# Replacement of tensioner and vibration damper

Manufacturers: Audi, Seat, Škoda, VW

Engine codes: AWT, AWM, ALT, AVJ, AMB, BFB, BEX, BKB, CFMA

Part nos: 531 0531 20 (replaced)  
 533 0028 20 (replaced)  
 530 0546 09 (new/Set)  
 530 0546 10 (new/KIT)

Image 1: Vibration damper 533 0028 20 (left), tensioner 531 0531 20 (right)

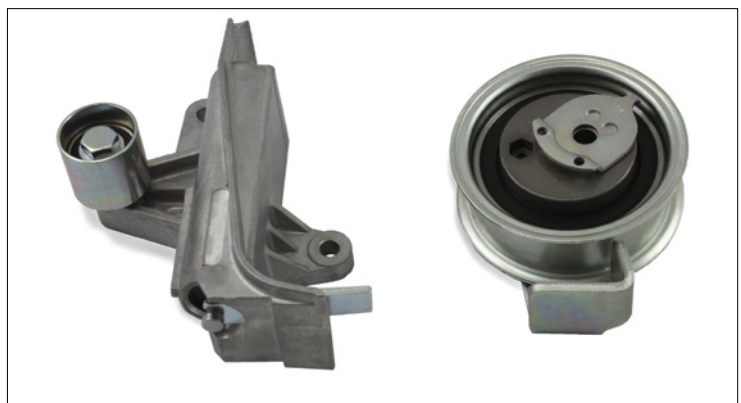
In the vehicles listed above, vibration damper 533 0028 20 (Image 1, left) and tensioner 531 0531 20 (Image 1, right) have been replaced with KIT 530 0546 10 (Image 2, left) and Set 530 0546 09 (Image 2, right).

The new components differ not only in terms of their appearance but also in terms of their functionality. With the old design, the vibration damper, in addition to the tensioner, took on part of the belt tensioning function.

The new deflecting pulley with holder 532 0601 10 only has a deflecting function. The belt tension and damping is carried out by tensioner 531 0840 10 only.

The use of mixed components is not permitted, as the components are adapted to one another and only ensure the correct belt tension when used together.
